ADDENDUM

DESCRIPTION: Scope clarification and revised bid form RFP #: CAP 7452	ADDENDUM NUMBER: 01
	DATE OF ISSUE: September 12, 2025
	ISSUED BY: Mike Ford
	PAGE(S): 1

Project Title: CAP 7452 **Exterior Finishes Rehabilitation**

Town of Canmore Utilities Buildings - Site Review 5

Image for Answer 5

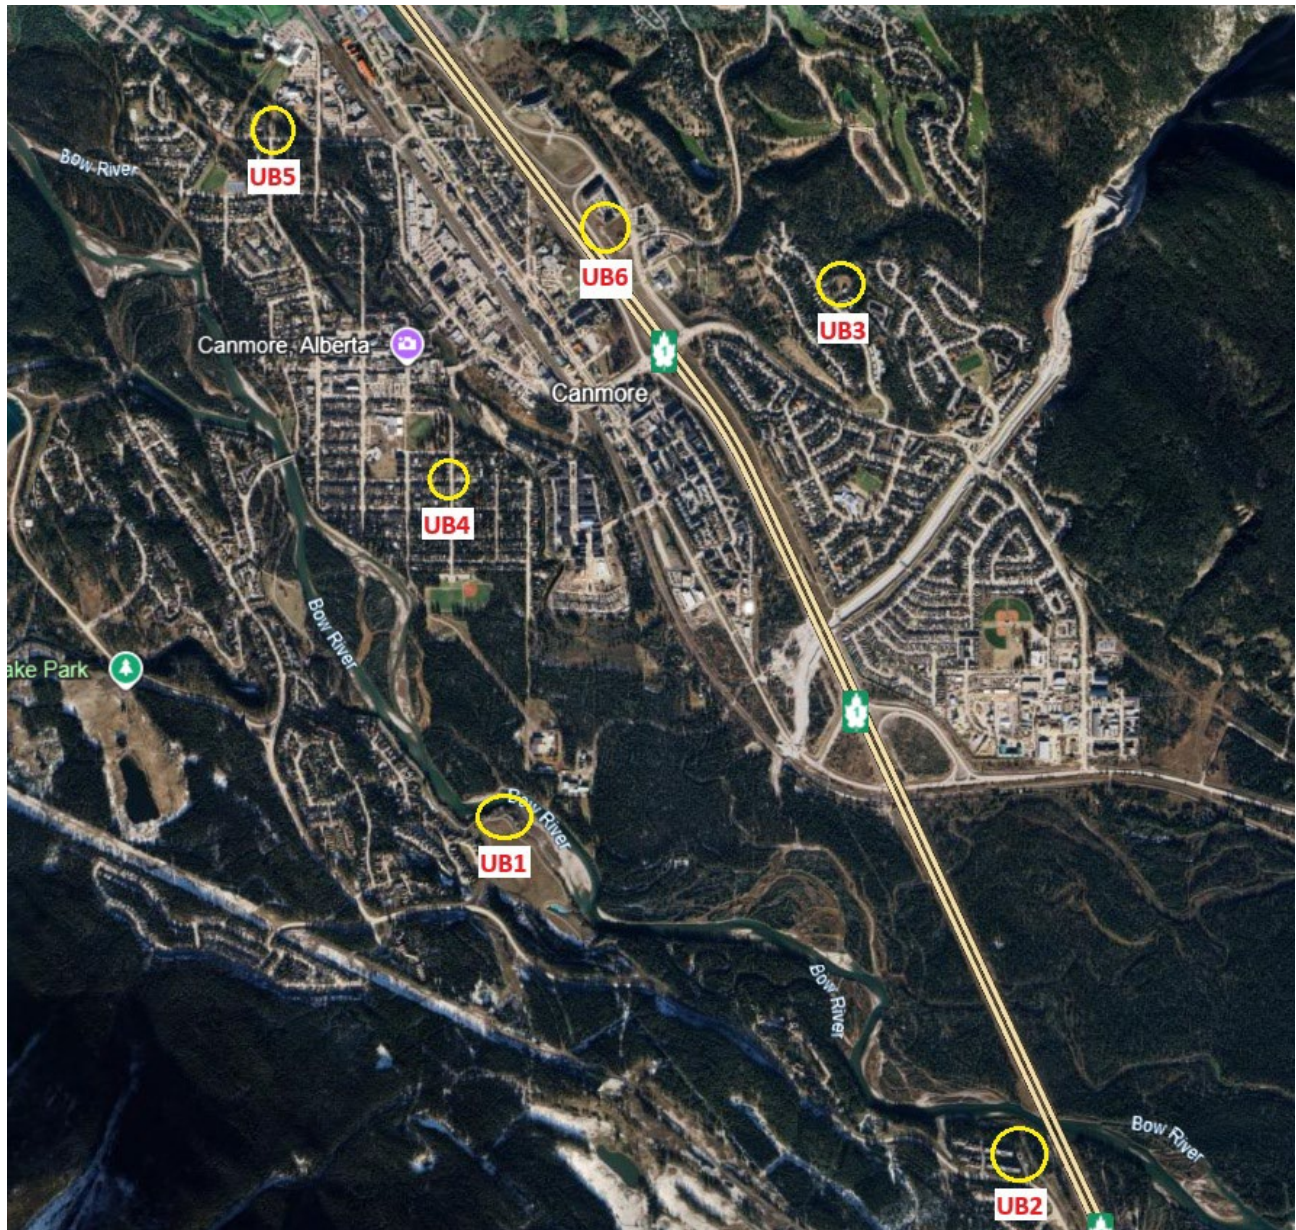
Will truck traffic be allowed to UB1?

Yes. Access can be coordinated through the Project Manager. See the attached image showing the nearest access point once the gate is unlocked.
